Consumers
Power
Company

MIDLAND NUCLEAR PLANT - ALAB-106 MONTHLY
NONCONFORMANCE REPORT FOR NOVEMBER 1975

In accordance with Condition 4 of Memorandum and Order ALAB-106 dated March 26, 1973 and Amendment No. 1 of the Midland Plant Construction Permit, enclosed are ten (10) copies of the nonconformance reports for November 1975. The report consists of copies of Bechtel Nonconformance Reports and Quality Audit Findings written or closed during the month, all sheets from the Bechtel Nonconformance Report Log and Status Book which reflect open Bechtel NCR's, and Consumers Power Company Nonconformance Reports written or closed during the month. There were no Bechtel Quality Assurance Discrepancy Reports or Management Corrective Action Reports written during the month of November.

SUBJECT Repair At 633'2" EL. 130° AZ. FILE NO _____

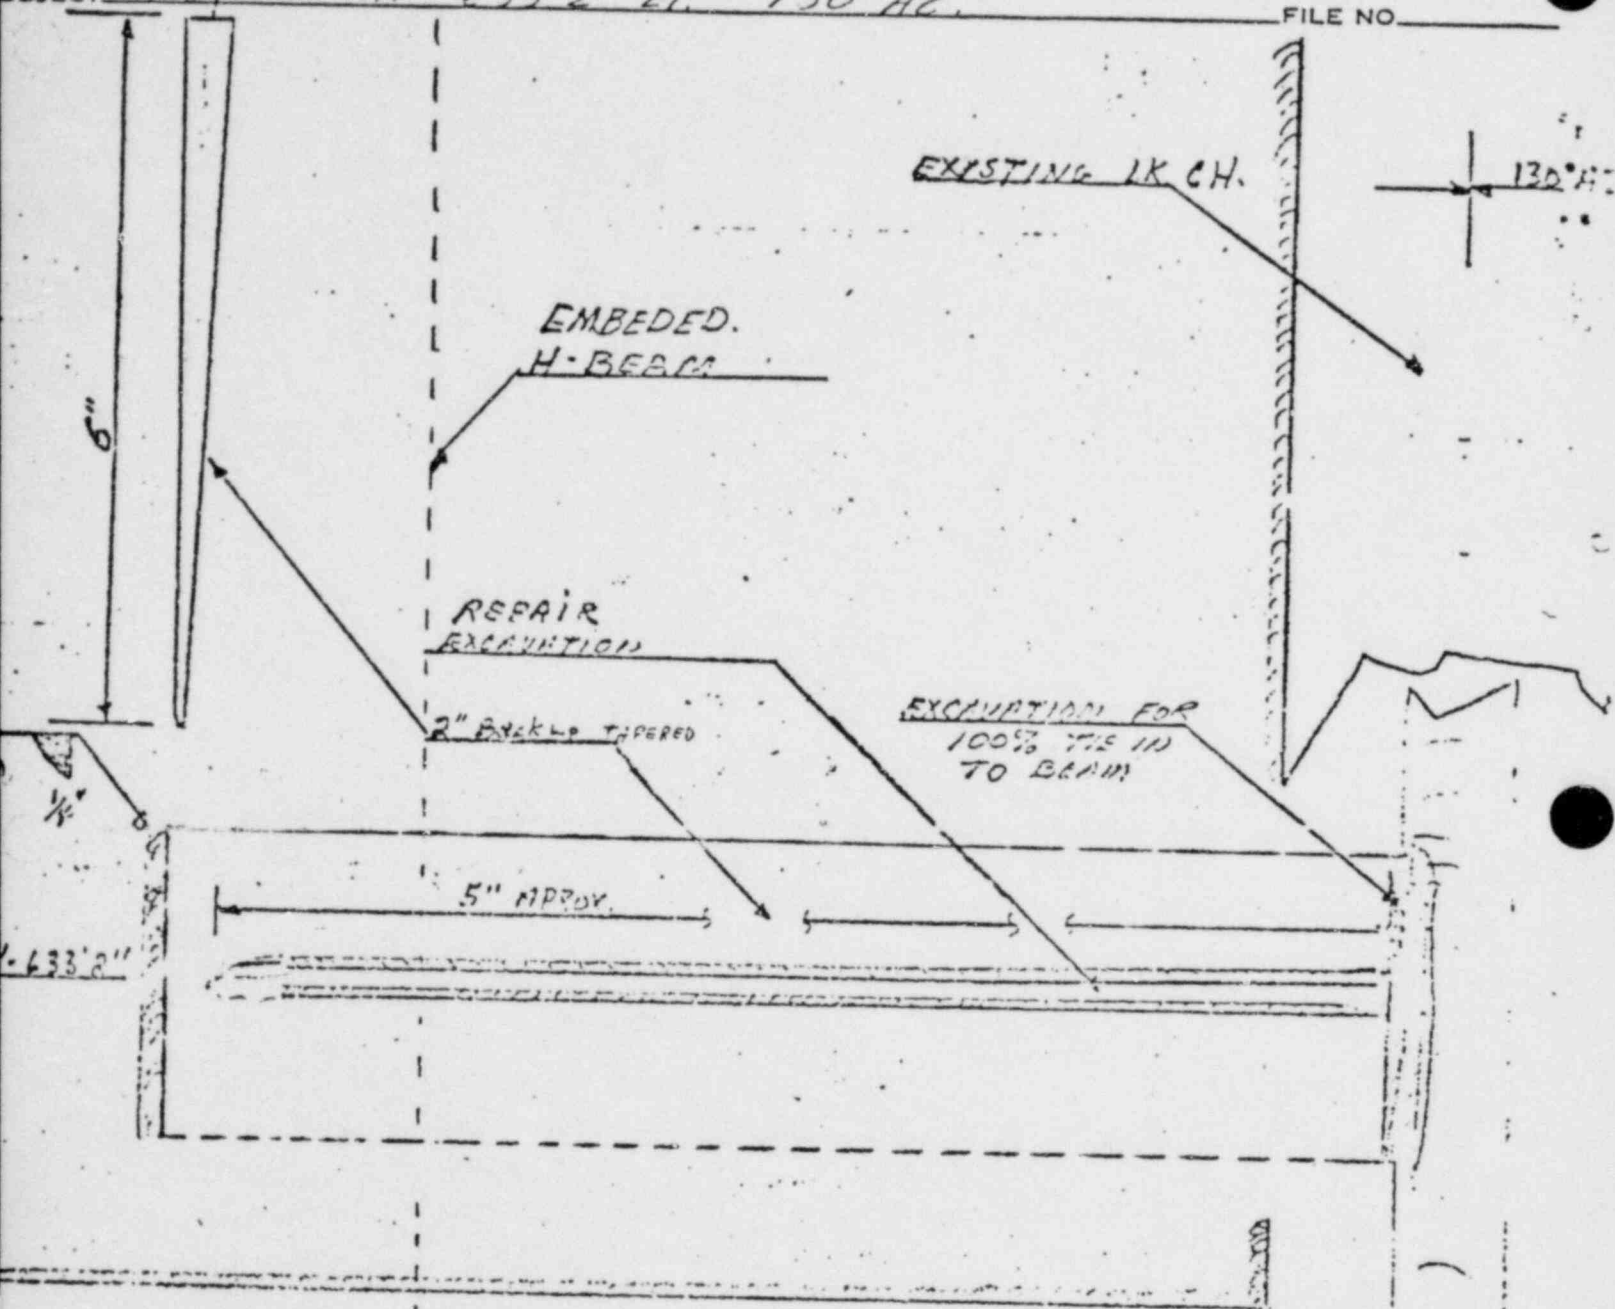
19. NONCONFORMING CONDITION: Through thickness leak detected in 1/4" liner plate during air pressure test of 130° Azimuth vertical seam weld leak chase at elevation 633'3". Further investigation by NDE revealed a linear discontinuity in the plate on a horizontal plane approximately 5" long to the left from 130° Azimuth seam weld. "Q" No. 1.109.

4. Repair the excavated area by full penetration butt weld, followed by NDE in accordance with Specification C-111.
5. Add leak chase channel over the repaired area.
6. Show the location of repair and new leak chase channel on the as-built drawings.
